**PLANNED UNIT DEVELOPMENT  
& SUBDIVISION STAFF REPORT****Date: May 2, 2019**

<b><u>DEVELOPMENT NAME</u></b>	Springhill Village Subdivision
<b><u>SUBDIVISION NAME</u></b>	Springhill Village Subdivision
<b><u>LOCATION</u></b>	4350, 4354, 4356, 4358, 4360, 4362, 4364, 4366 and 4376 Old Shell Road (North side of Old Shell Road, 390'± West of Dilston Lane, extending to the East side of North McGregor Avenue, 480'± North of Old Shell Road).
<b><u>CITY COUNCIL DISTRICT</u></b>	District 7
<b><u>AREA OF PROPERTY</u></b>	2 Lots / 10.9± Acres
<b><u>CONTEMPLATED USE</u></b>	Planned Unit Development Approval to amend a previously approved Planned Unit Development to allow multiple buildings on a single building site, shared access and parking and reduced front yard setbacks to accommodate new businesses; and Subdivision Approval to create two legal lots of record.
<b><u>TIME SCHEDULE FOR DEVELOPMENT</u></b>	None given.
<b><u>ENGINEERING COMMENTS</u></b>

# DETAIL SITE PLAN

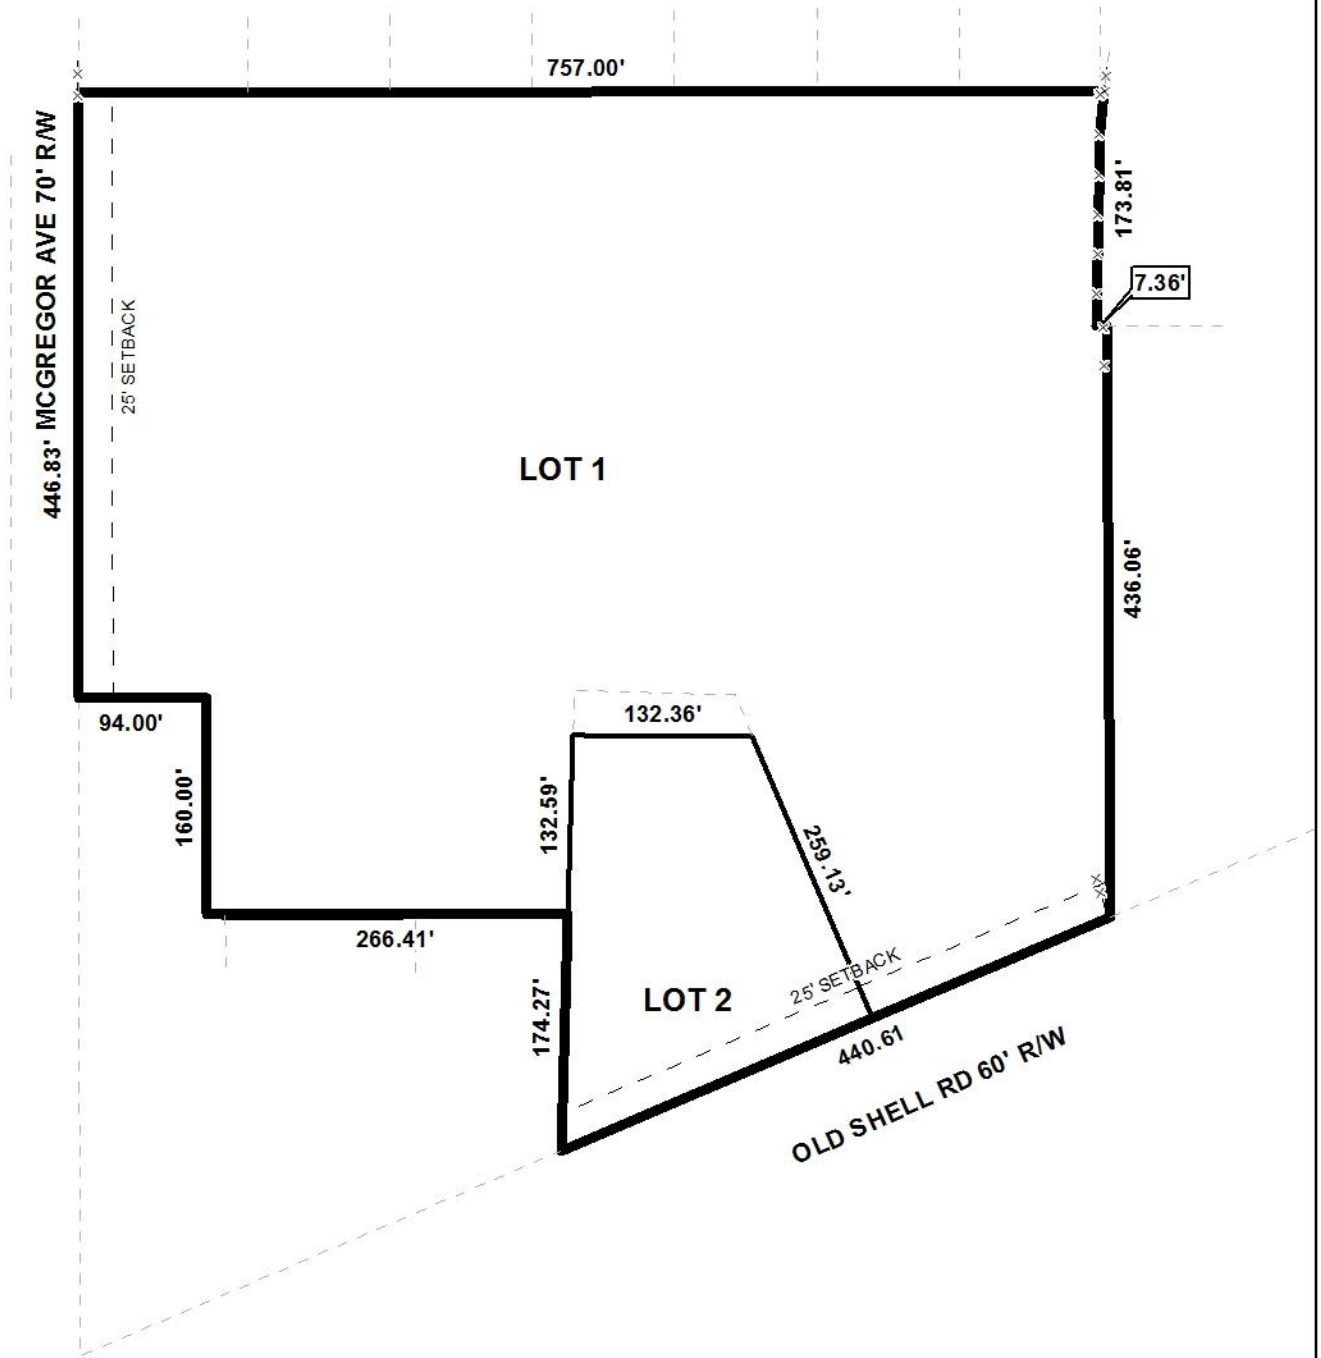
The proposed lots, as depicted, meet the minimum size requirements of the Subdivision Regulations. The lot size areas are labeled on the plat in both square feet and acres and should be retained on the Final Plat, or a table should be furnished on the Final Plat providing the same information. The PUD site plan provides the area for the shopping center only. Therefore, the site plan should be revised to label the area of the bank property in both square feet and acres, or a table should be furnished on the site plan providing the same information.

The 25' minimum building setback line is depicted on the preliminary plat along both street frontages for both properties. However, as the Regulating Plan for the TCD allows for a front build-to line from zero to five feet back from the front property line, the Final Plat should be revised to indicate this setback along both street frontages for the shopping center property. The normal 25' minimum building setback line should remain along Old Shell Road for the bank property. The PUD site plan should be revised to indicate the setbacks as per the revised Final Plat.

- 2) revision of the plat to indicate a zero to five-foot building setback line along both street frontages for Lot 1 (shopping center site);
- 3) retention of the 25' minimum building setback line along Old Shell Road for Lot 2 (bank site);

# SITE PLAN

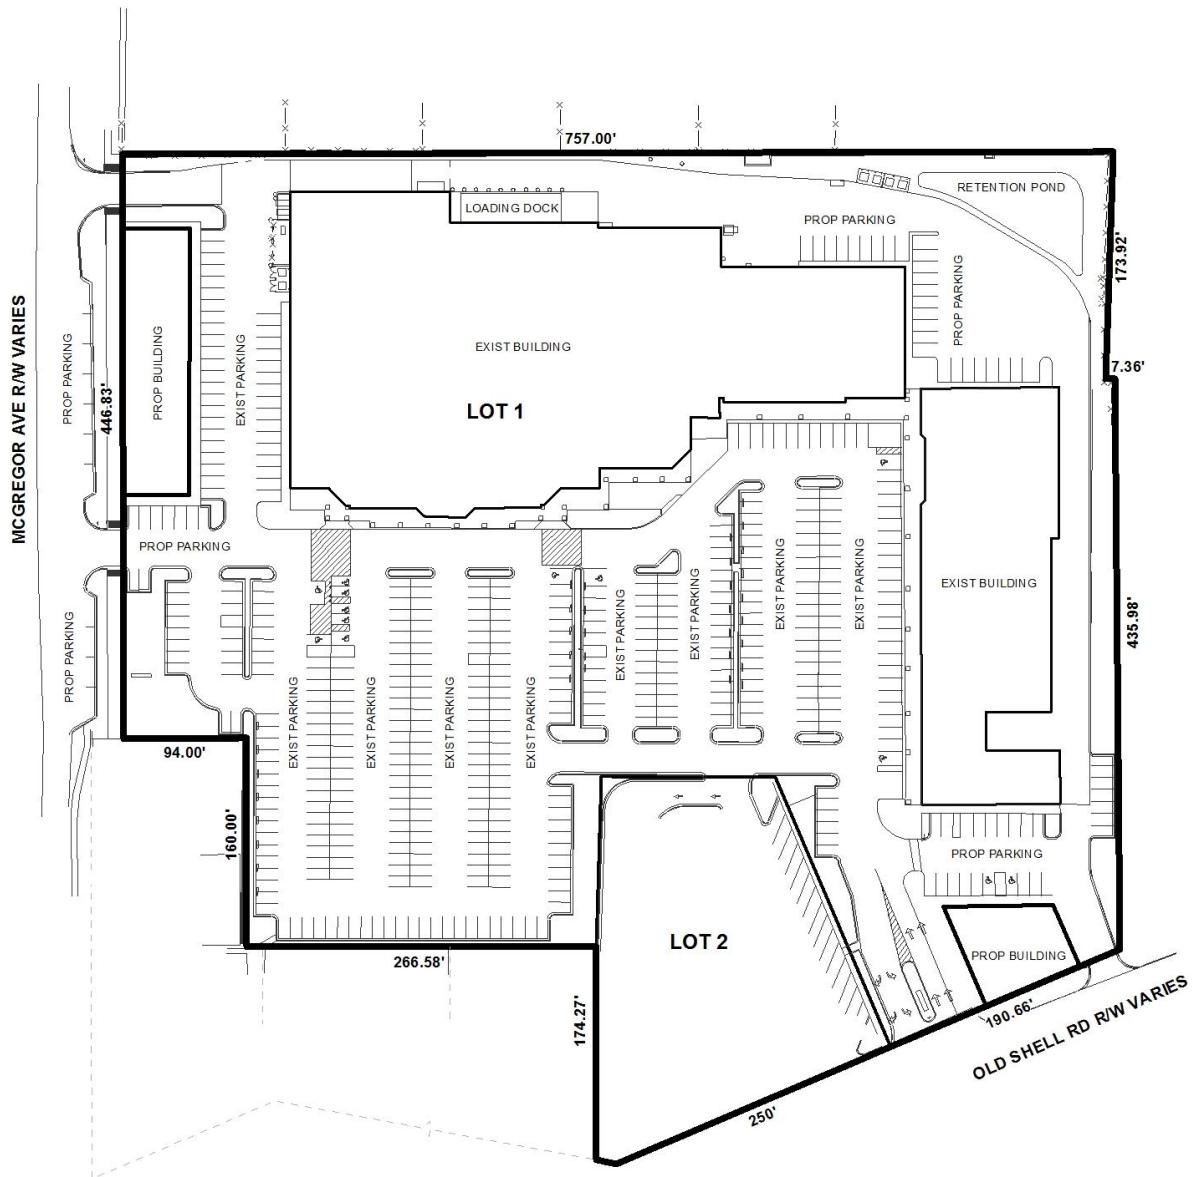
- 1. Retain NOTES 1 – 7 shown on the PROPOSED SPRINGHILL VILLAGE REDEVELOPMENT (OPTION A) PUD site plan.
- 2. Show and label all proposed improvements.

The Regions Bank site is only outlined on the PUD site plan with very little specific site detail shown with regard to buildings, traffic aisles, front curb cuts, etc. Therefore, the over-all PUD site plan should be revised to also include site details for the bank property as shown for the shopping center property.

As the same new buildings are indicated as proposed under the previous PUD approval, and as the parking requirements are as per the TCD Regulating Plan, the site plan should be revised to provide a chart of parking calculations based on the ratio of one space per 450 square feet of gross floor area for general business uses, one space per 300 square feet of gross floor area for restaurant/lounge area, and no parking required for residential use, with all fractional numbers rounded up.

No landscaping or tree planting is indicated on the site plan. As per the TCD Regulating Plan, 10% of the total building site being developed or redeveloped must be landscaped. As per the previous PUD approval, the site plan should be revised to provide landscaping and tree planting for 10% of the total site, to be coordinated with the Planning and Zoning staff prior to submittal. As no new development is proposed on the bank site, no landscaping plan would be required for that portion of the PUD.

- 1) revision of the site plan to label both lots in both square feet and acres, or the furnishing of a table on the site plan providing the same information;
- 2) revision of the site plan to include site details for the bank site similar to those shown on the shopping center site;
- 3) revision of the site plan to indicate a zero to five-foot building setback line along both street frontages for Lot 1 (shopping center site);
- 4) revision of the site plan to indicate a 25' minimum building setback line along Old Shell Road for Lot 2 (bank site);
- 5) revision of the site plan to provide a chart of parking calculations based on the ratio of one space per 450 square feet of gross floor area for general business uses; one space per 300

- square feet of gross floor area for restaurant/lounge use; and no parking required for residential use, with all fractional numbers rounded up;
- 6) revision of the site plan to provide landscaping and tree planting for 10% of the shopping center site (Lot 1), to be coordinated with the Planning and Zoning staff;
